### **Gemini Project (APP0043095): Notification of Change**

This notice is provided to the Department of Environment and Science (the Department) on behalf of the applicant, Magnetic South Pty Ltd (**Magnetic South**), pursuant to s132(1)(a) of the *Environment Protection Act 1994 (EP Act)* to outline changes made to the layout of the proposed Gemini Project (the **Project**), since the application was originally submitted on 23 October 2019.

Figure 2 Revised Project Layout

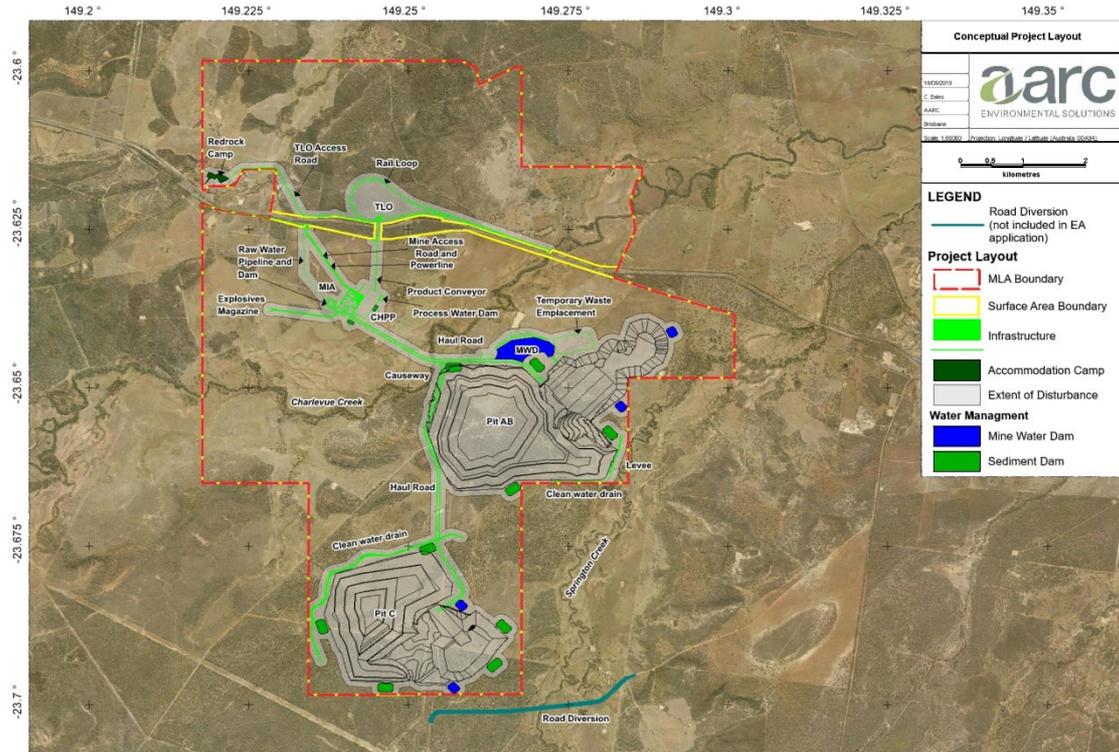
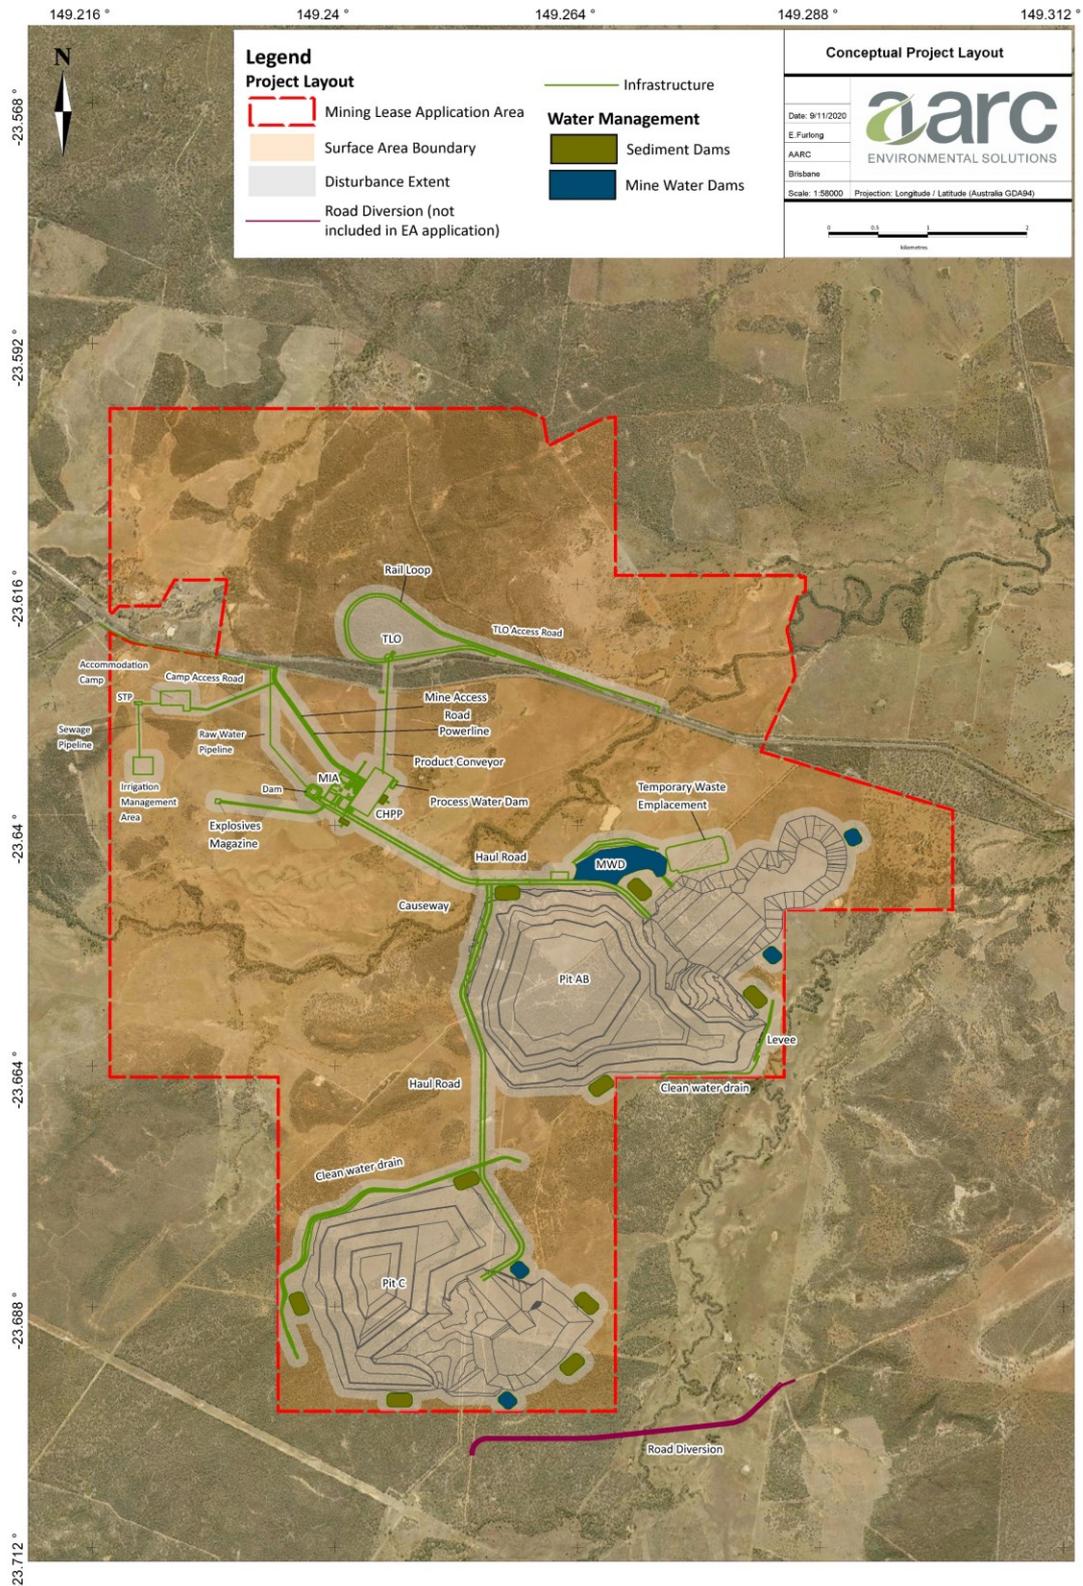
Changes to the general layout of the Project have been made in response to landholder consultation, submissions made on the EA application, further investigation of site conditions, and environmental assessments. The original Project layout is provided in the attached Figure 1, with the changed layout attached as Figure 2. The changes contribute to a reduction in the Project's disturbance area from 1961.2 ha in the original application to 1953.5 ha with the revised layout. The revised layout reduces the number of properties directly impacted by the proposed mine development.

The original application proposed that the workers' accommodation and associated infrastructure (camp access road, sewage treatment plant, sewage pipeline and effluent irrigation management area) would be located on Lot 100 on RP882349 (**Redrock Park**), accessed via the public Redrock Park and Pine Grove Roads. This property is not owned by Magnetic South, and is located on the northern side of the Capricorn Highway.

The changed layout locates the camp and associated infrastructure to the south of the Capricorn Highway, on Lot 4 on RP801280 and Lot 1 on HT424, accessed via the main mine access road. Both of these properties are owned by Magnetic South.

This change was primarily in response to a submission made during the notification stage by the owner of Redrock Park. The submission raised concerns regarding potential traffic, noise and dust impacts on the residence and existing accommodation facility on the property. Whilst Magnetic South does not concede that the submission accurately outlines the likely impact of the proposed activities, by removing the proposed camp and associated infrastructure from Redrock Park, the potential for the impact identified in the submission has been reduced or removed.

The original application included a train loadout (**TLO**) access road approaching the TLO from the west, via Redrock Park, along with another access from the east via the intersection of Red Hill Road and the Capricorn Highway.

Whilst Magnetic South does not concede that the submission by the owner of Redrock Park accurately outlines the likely impact of the proposed activities, to address the concerns identified in the submission regarding potential noise, dust and traffic impacts, the western TLO access road has also been removed from the Redrock Park Property. All access to the TLO will now be via the eastern Red Hill Road access, reducing or removing the potential impacts from dust, noise and traffic on the Redrock Park residence and accommodation facility. Removal of one of the TLO access roads naturally reduces the disturbance footprint of the Project.
